LEE COUNTY HISTORIC PRESERVATION BOARD

SPECIAL CERTIFICATE OF APPROPRIATENESS DECISION
SCA2025-00008

Designation No.: HD90-10-01
Name of Project: 11458 May Street Quadplex to Duplex
Location: 11458 May Street, Matlacha, FL 33993
Strap No.: 24-44-22-07-00000.0370
Applicant/Agent: Chris Walczak
E-Mail: [c m walczak@yahoo.com](mailto:c_m_walczak@yahoo.com)

Request: The applicant requests to modify the previously approved SCA2023-00020, which allowed for the elevation and reconstruction of the existing quadplex, to redesign the second-floor level to a duplex. The request includes redesigning new upper floors on top of the existing building and converting the ground floor into storage space.

Front Building Elevations

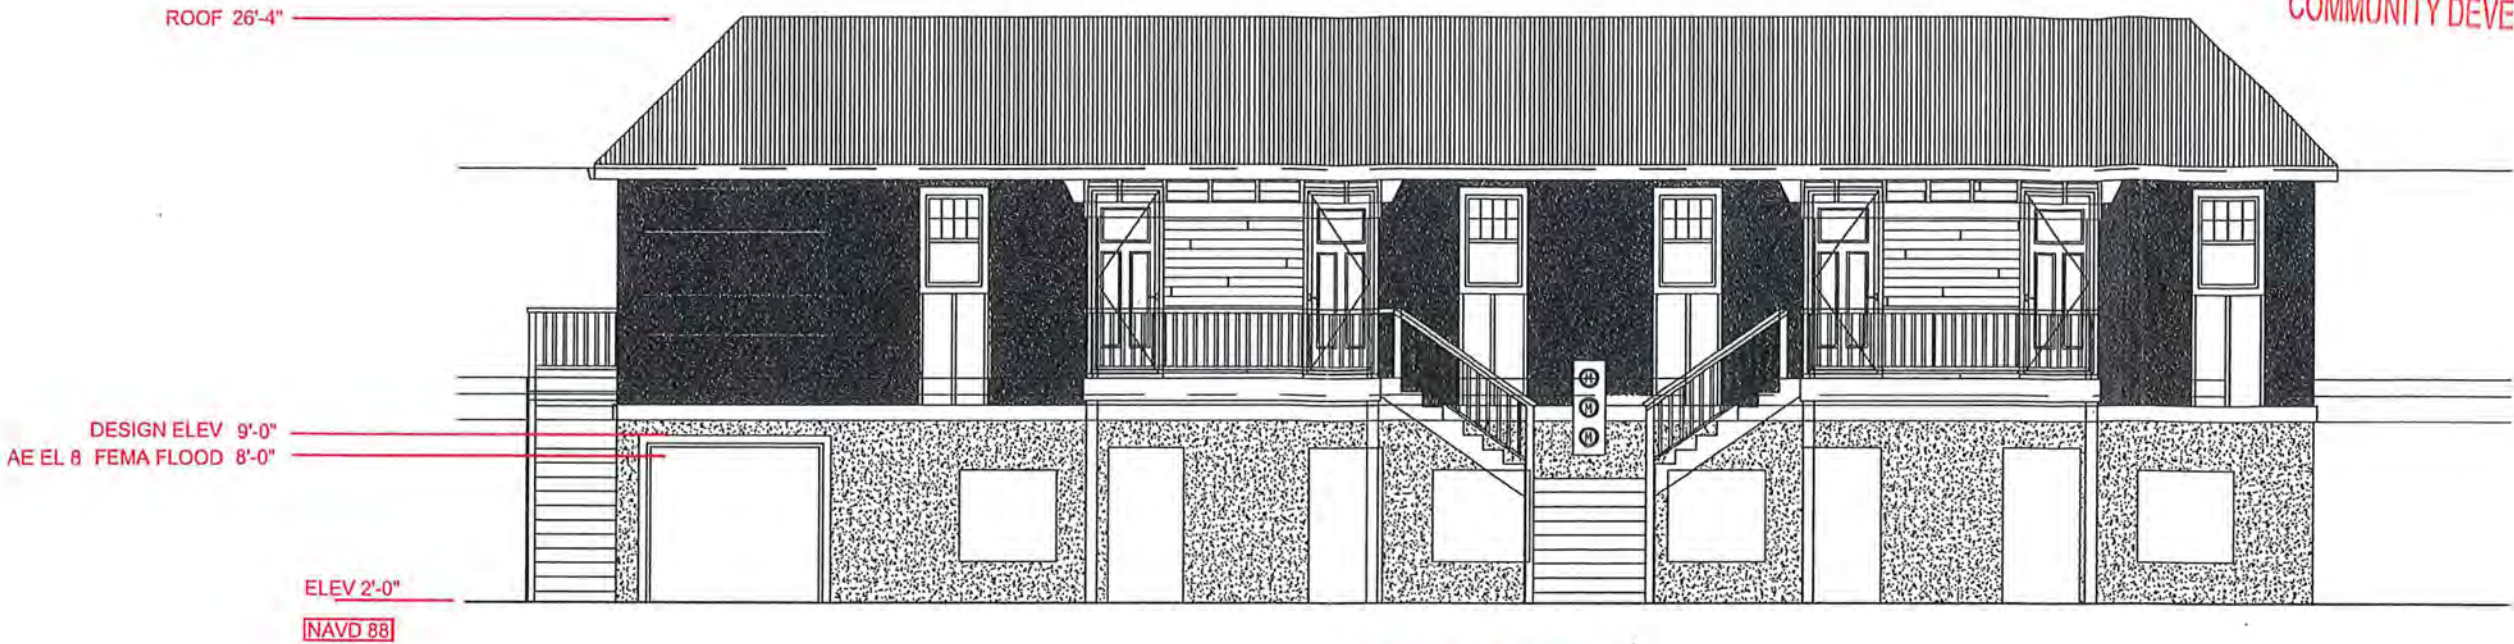
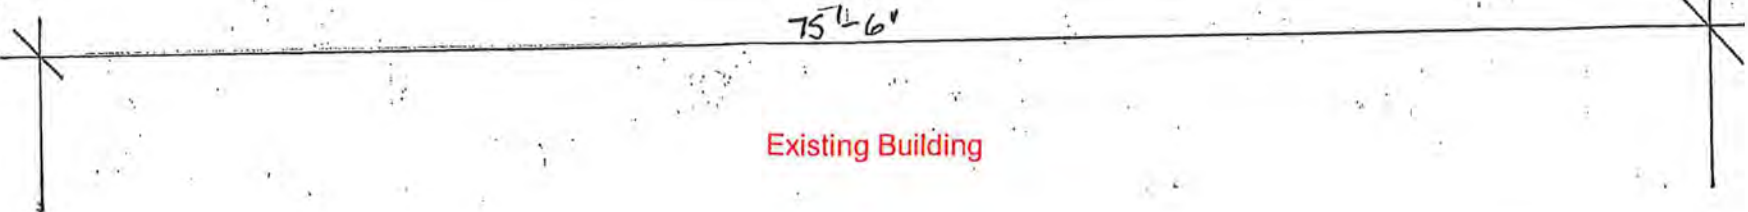
Southwest Elevations

The southwest facing (front) elevation faces onto May Street. The front façade open to the street and used for tenant storage. A single external staircase will split into two 90-degree turns to the upper landings which will provide access to the two second floor dwelling units. The second-floor level will use two single doors for access into each of the units, and provide horizontally placed windows, keeping with the style of the existing structure and neighboring homes.

Rear Building Elevation

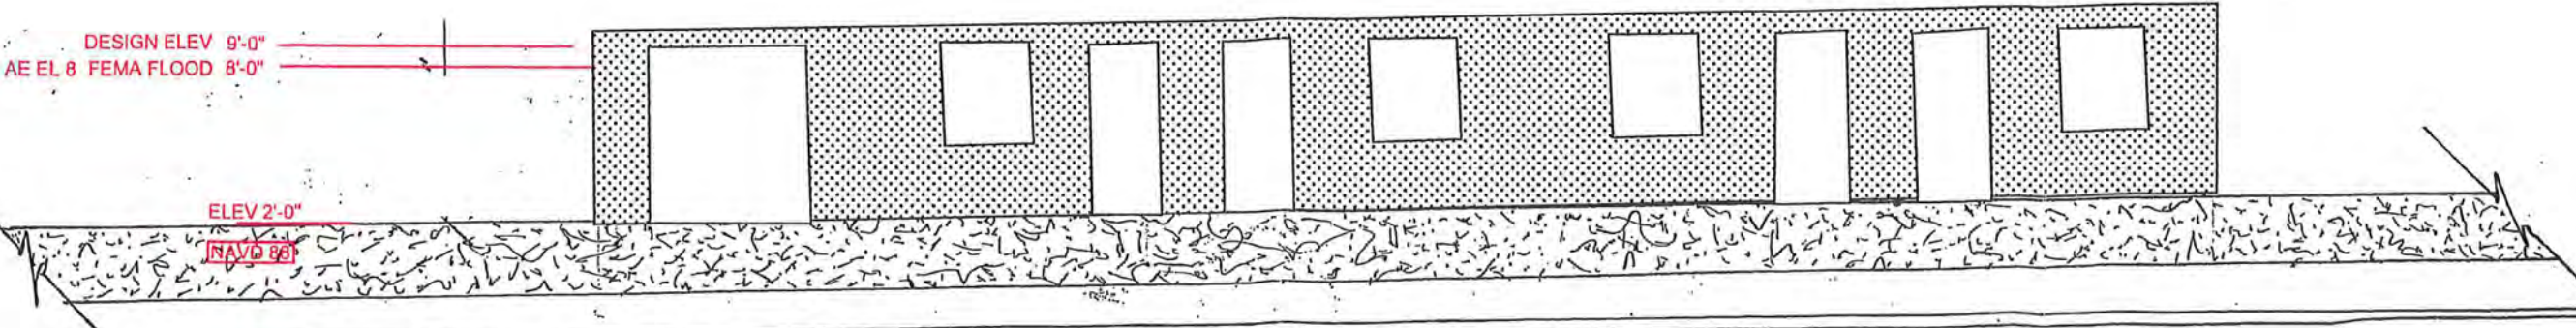
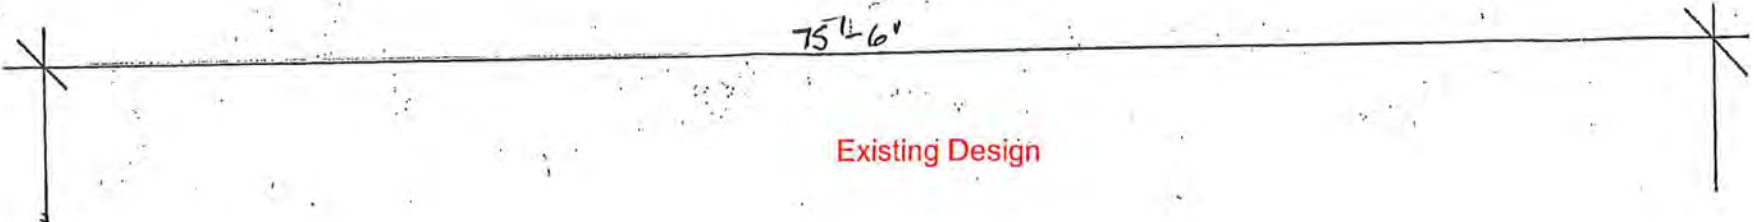
Northeast Elevation

The northeast facing (rear) façade ground level will fill in existing windows and create openings for access into the tenant storage area. The second-floor will include the newly designed eight-foot deck across the back of the entire building. Each unit will be accessible with two sliding glass doors, and one horizontally placed window for each unit will be provided. The common laundry facility will be accessible by sliding glass door from the rear deck.
